251 Camden High Street
London, NW1 7BU

Basement Impact Assessment
Audit

For
London Borough of Camden

Project Number: 12336-49
Revision: F1

CONSTRUCTION SEQUENCE
251-259 CAMDEN HIGH STREET.
4352/SK/160520/TKL/00

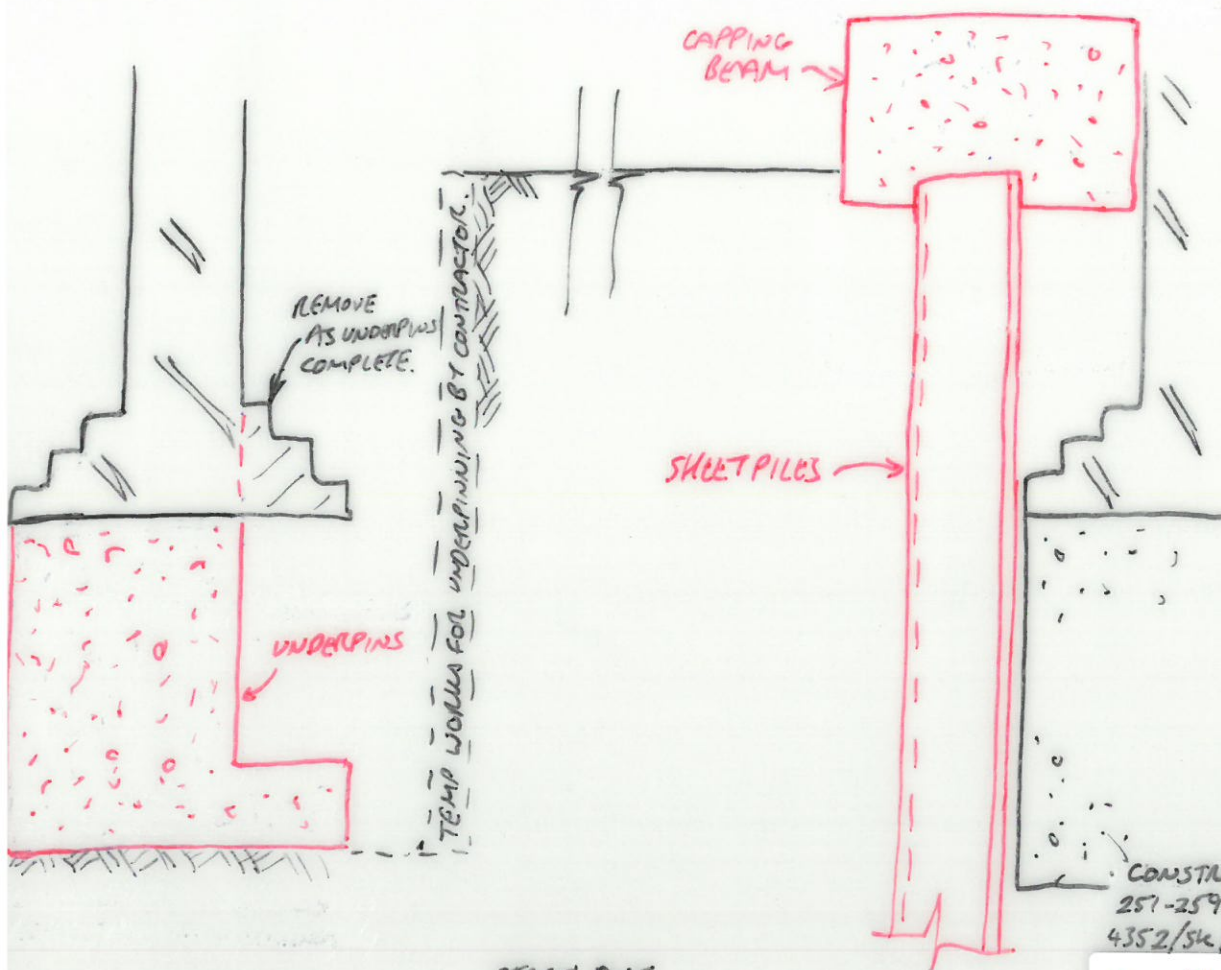
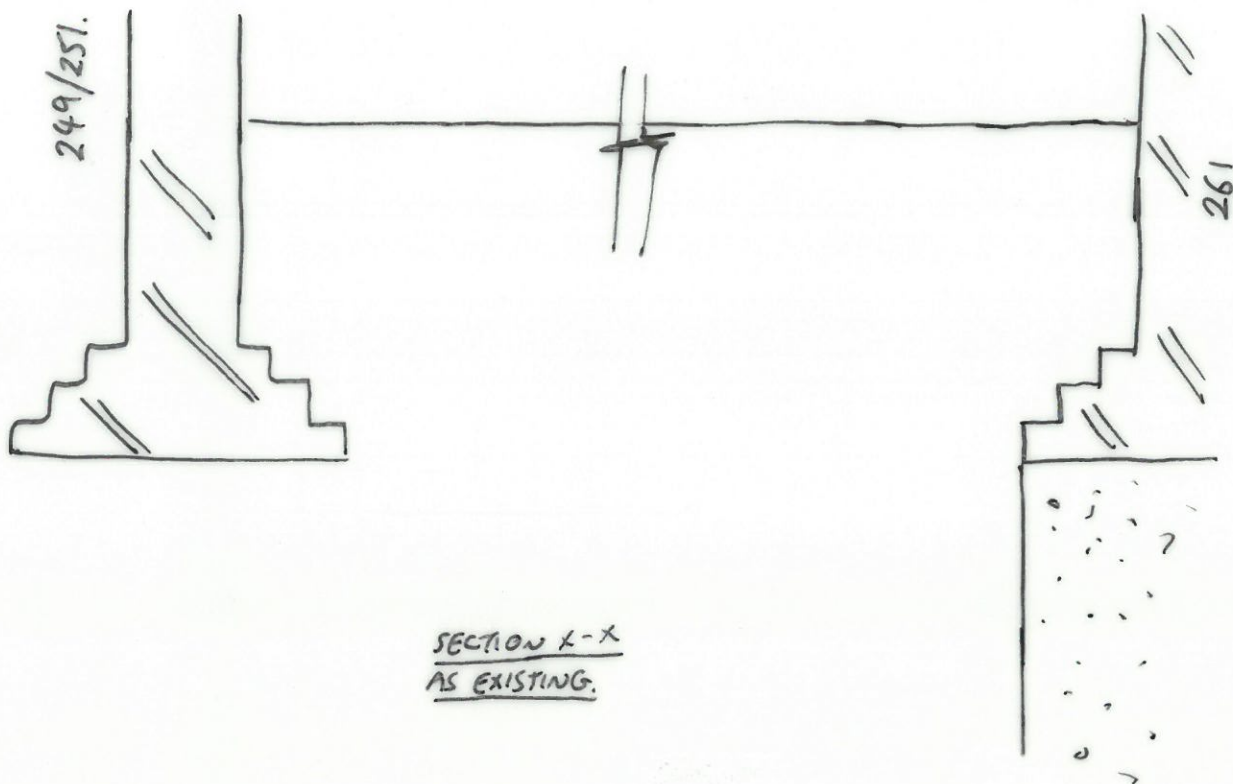
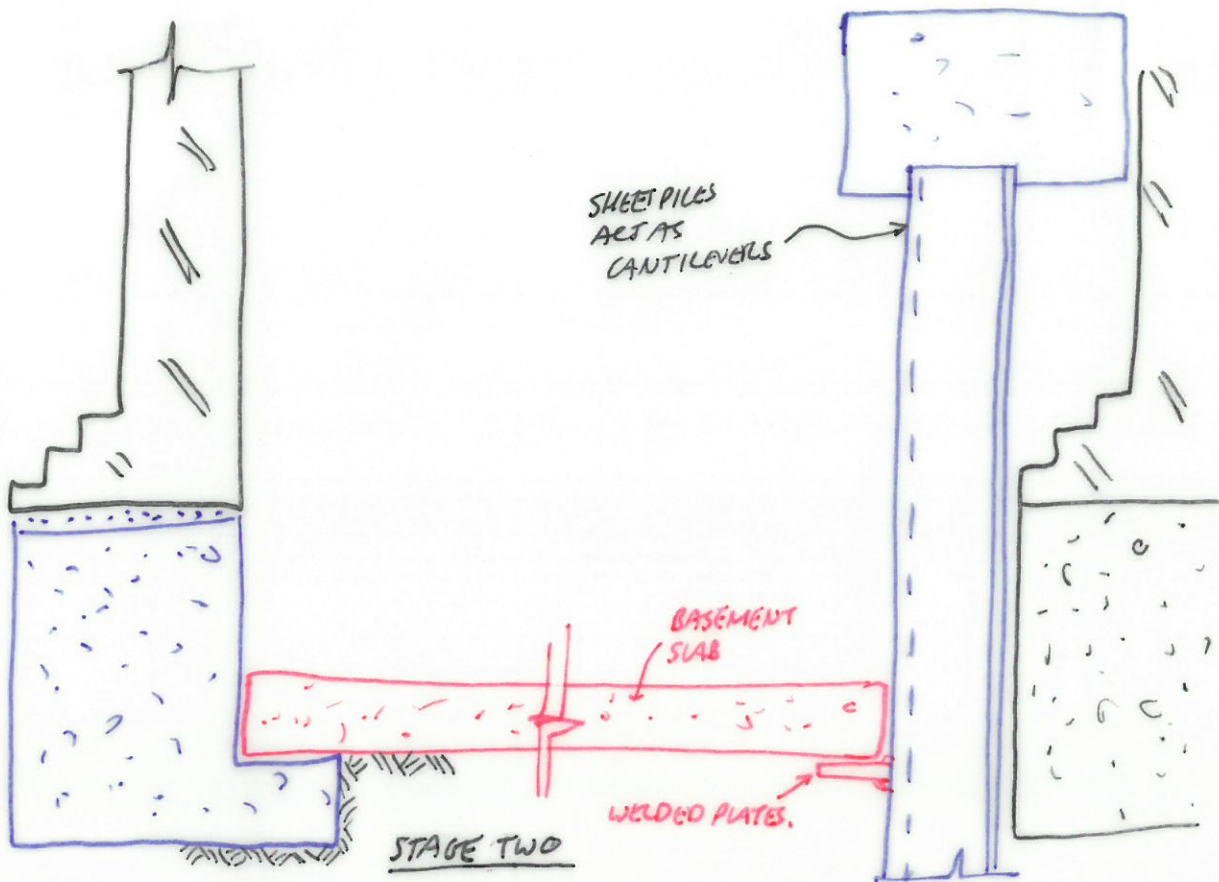
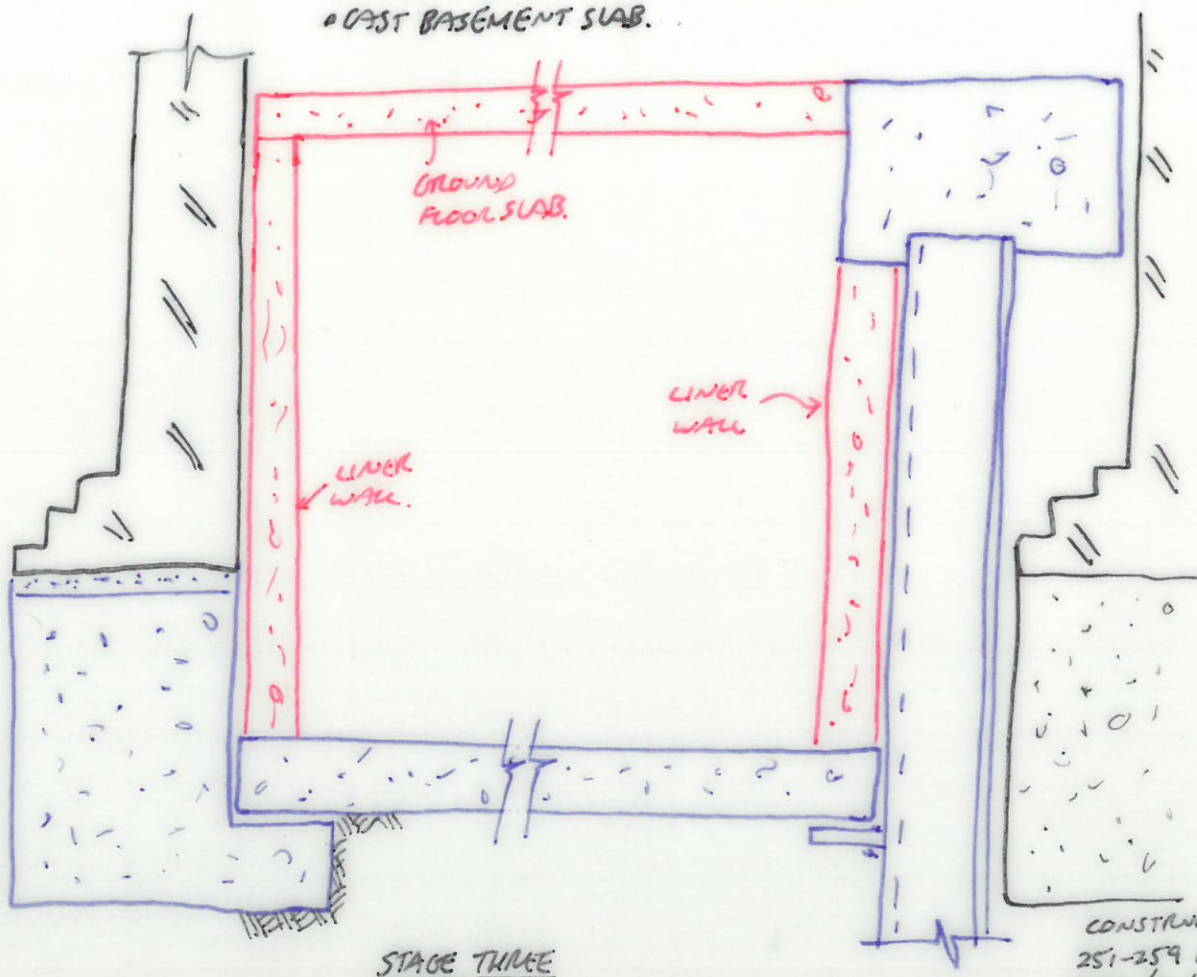
- 4.11. Reference is made to structural design by the engineers Walsh Associates. Suitable outline discussions on construction methodology and recommendations for undertaking underpinning is provided in the BIA, along with outline sketches (refer to Appendix 3). Detailed methodology, sequencing and propping arrangements should be presented in a BCP.
